CITY OF ALBUQUERQUE

RE: **7212 Menaul NE**
Grading Plan Stamp Date: 6/19/19
Drainage File: H19D040

RE: **7212 Menaul NE**
Grading Plan Stamp Date: 5/28/19
Drainage File: H19D040

<div>ENGINEER'S SEAL</div> <div></div> <div>6/19/19</div> <div>DAVID SOULE P.E. #14522</div>	7212 MENAUL	DRAWN BY WCUJ
	GRADING AND DRAINAGE PLAN	DATE 6-19-19
	 Rio Grande Engineering 1606 CENTRAL AVENUE SE SUITE 201 ALBUQUERQUE, NM 87106 (505) 872-0999	2108040-LAYOUT-5-10-19
		SHEET # JOB # 2109040

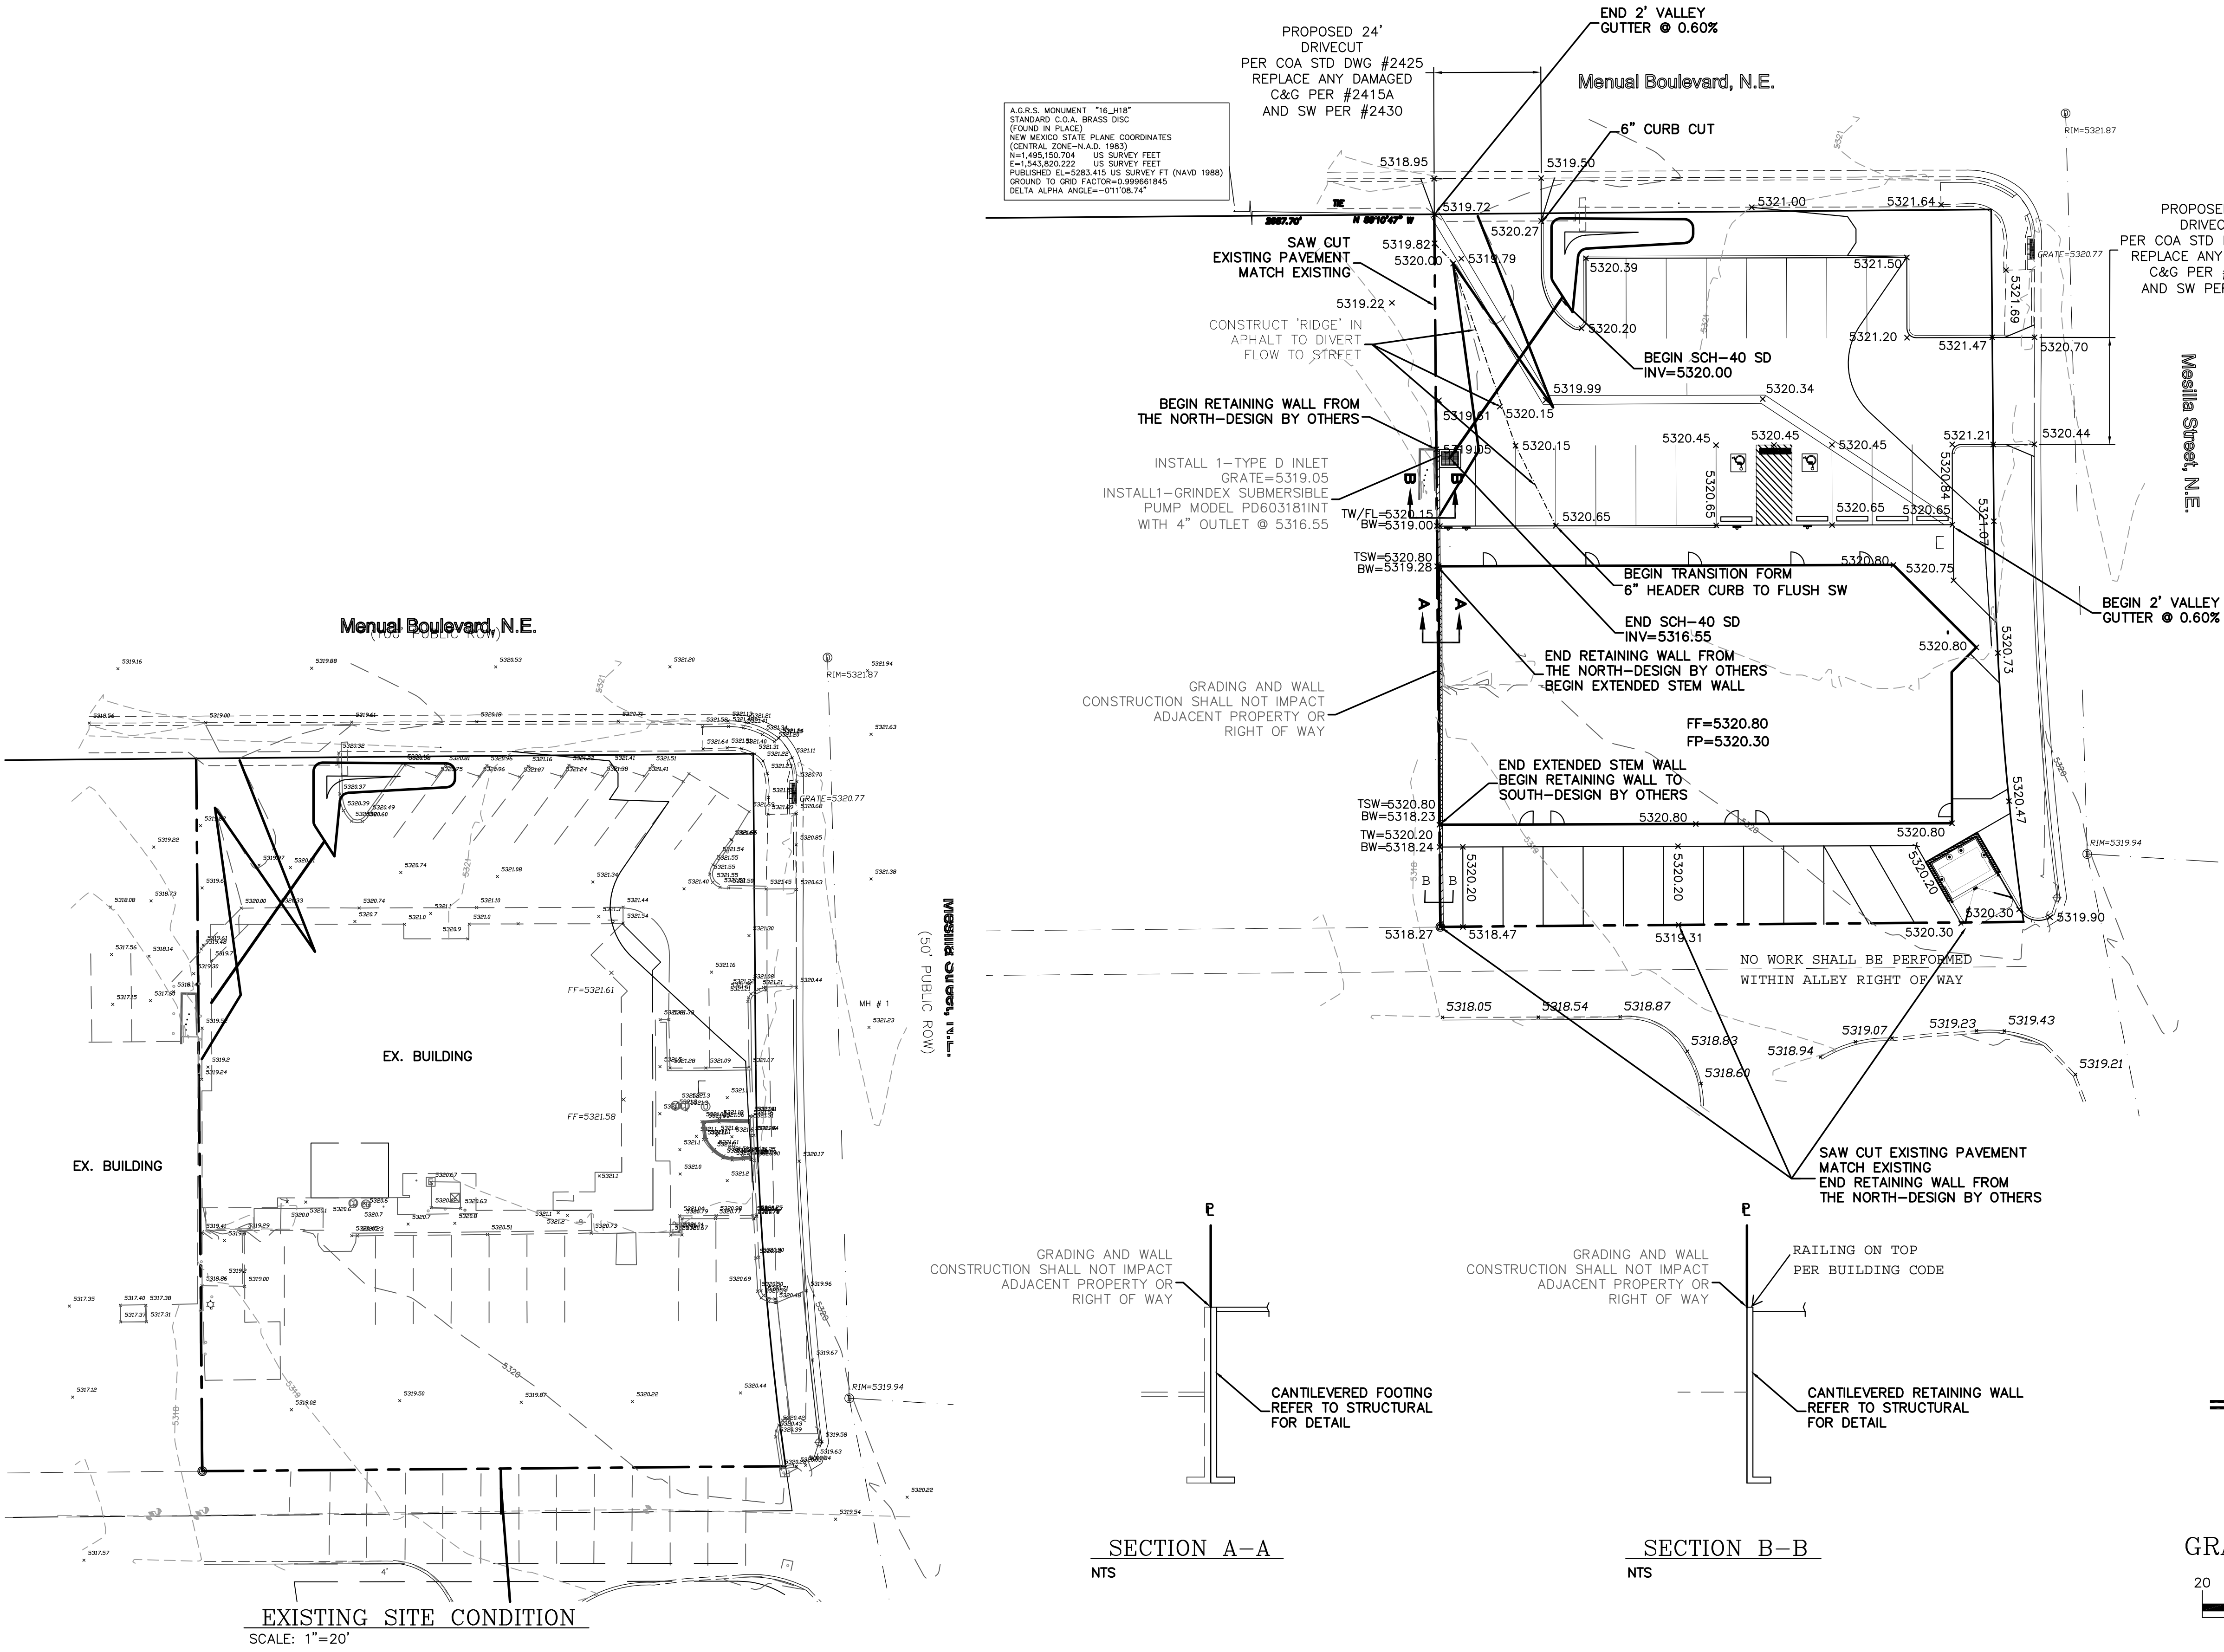
1. Show the grading and site work for repaving the alley; this work is required per the approved TCL. Modify the note to state "No work shall be performed in the Alley ROW without an approved work order or excavation/barricading permit." A modified alley section may need to be approved by Transpiration (and Hydrology) to keep public water from entering private property.

2. The drainage calculations and narrative are missing from the plan now.
3. Including the inlet pump and force main seems unnecessary. A valley gutter or trench drain w/ drain line through the curb, along the property line, seems more economical.

4. If the force mains stays, include a detail for the pond, curb-cut outfall, and force main outfall, including elevations. Right now it appears the force main outfalls at 20.0', but the pond outfalls at 20.27', meaning the pond will back up into the force main and the pump will run until it evaporates.

Based on the submittal received on 5/29/19, the grading plan cannot be approved until the following corrections are made:

1. Show the grading and site work for repaving the alley. **Alley is paved and not impacted**
2. Provide proposed contours and increase the density of existing and proposed spot elevation along the property line. Hydrology is especially interested in the tie-in to the alley and the property to the west. **ADDED SPOTS AND CONTOURS**

3. Provide sections through the west property line showing proposed retaining walls, garden walls, property/ROW lines, existing and proposed grades. In accordance with DPM Ch.22, section 5 part B, grading and wall construction near the property line may not endanger adjacent property or constrain its use. **ADDED CROSS SECTION AND NOTE**

4. The note to end the valley gutter at the Manual entrance also says to begin a retaining wall. Will this cut-off access to the property to the west? Show the retaining wall location.
CORRECTED THE NOTE

5. What is the building use? For trash enclosures serving food service developments, demonstrate *control of liquids from dumpster areas* per DPM Chapter 22.9.E, Table 1 by containing runoff from the dumpster area and discharging to the sanitary sewer. If this information is on the utility plan please provide it, or show on the grading plan.
RETAIL SALES AND GOLD/SILVER EXCHANGE, NO FOOD SERVICES

6. Provide a Bernalillo County recorded drainage easement granted by the property owner to the west for discharging across their property, or modify the grading to eliminate cross lot drainage.
ADDED INLET AND PUMP FOR THE AREA THAT CAN NOT DRAIN ON SURFACE TO MENAUL
